Re: Bowie Resources, LLC, Bowie No. 1 Mine  
Technical Revision #115, revise underdrain location  
Adequacy Response #1

DRMS' letter dated April 18, 2018 transmitted its adequacy review for the referenced technical revision. On behalf of Bowie Resources LLC, following are its responses to the DRMS' comment and concerns.

**MAP NO. 15-**

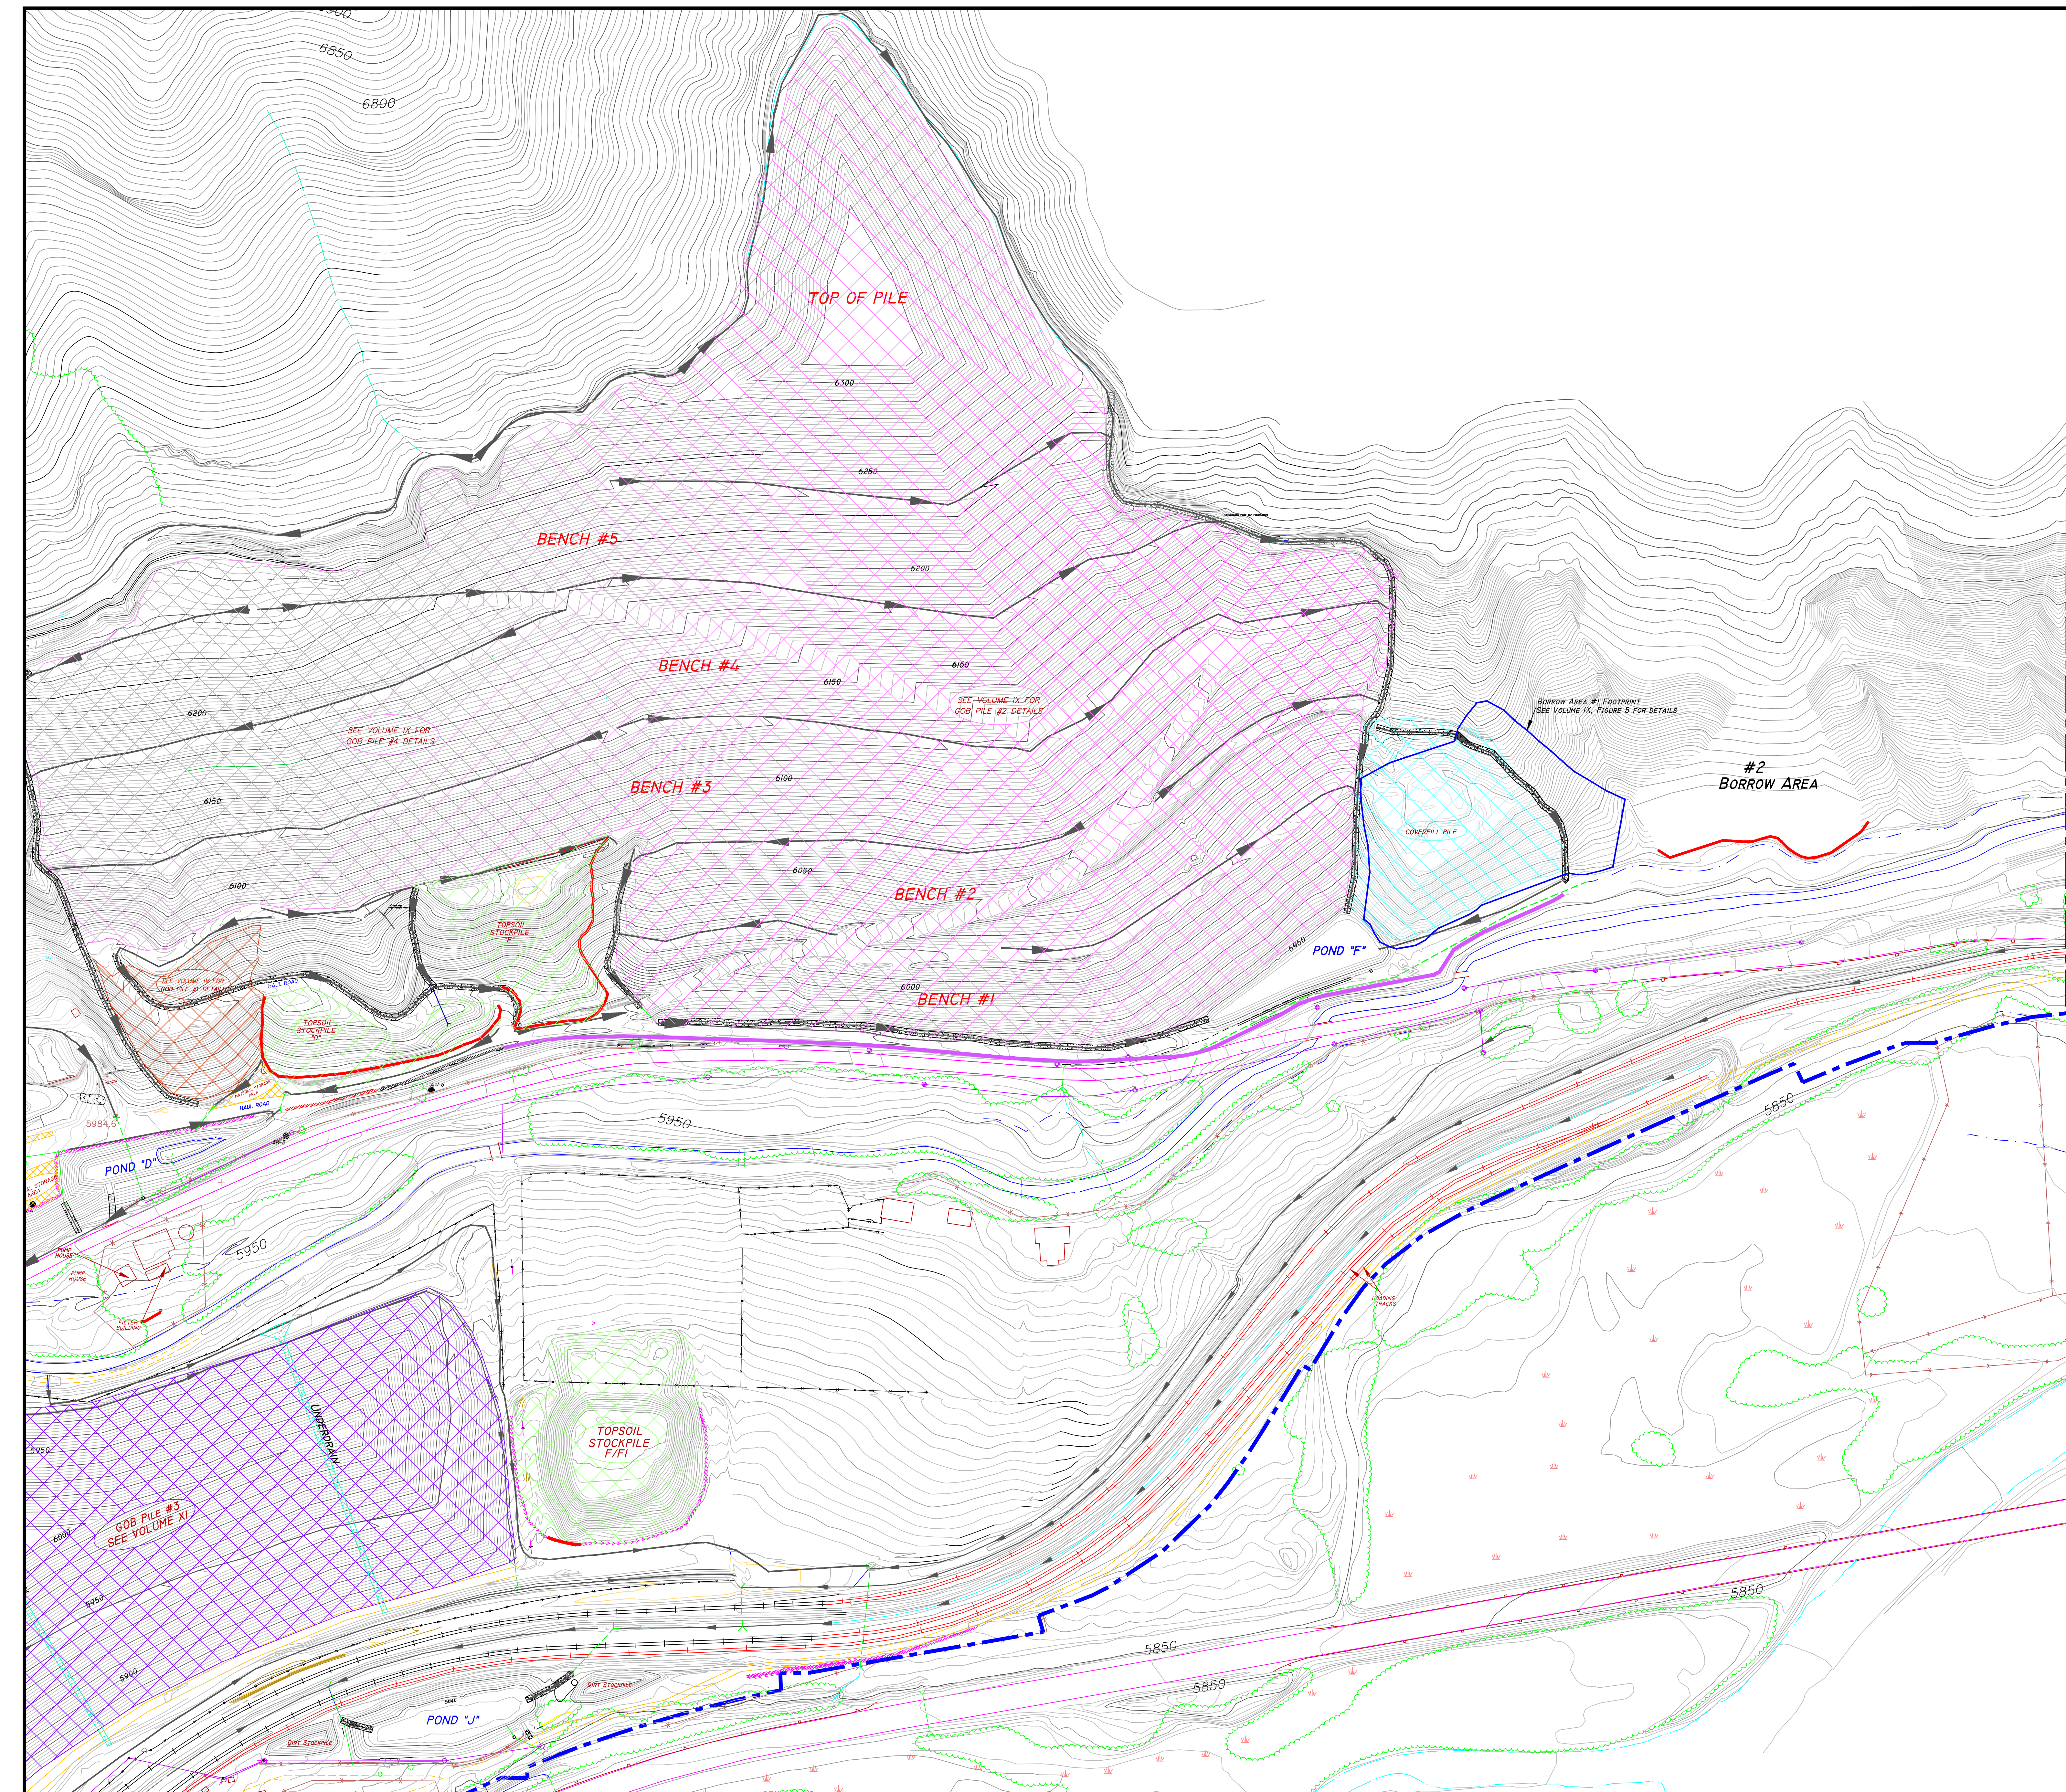
1. **DRMS:** The extent of riprap for the East Diversion Ditch is somewhat inconsistent between the three submitted maps. On Map 21-3 the symbol for riprap extends well above the confluence with Ditch D-F1. On Map 15-3 and Map 20 the rip rap is shown ending at Ditch D-F1. Please revise maps as appropriate and re-submit them to the Division.

**BRL:** The riprap location has been revised on **Maps 15-3 and Map 20** to be consistent with Map 21-3. In addition, the viewports have been changed to show the full extents of the East Diversion Ditch.
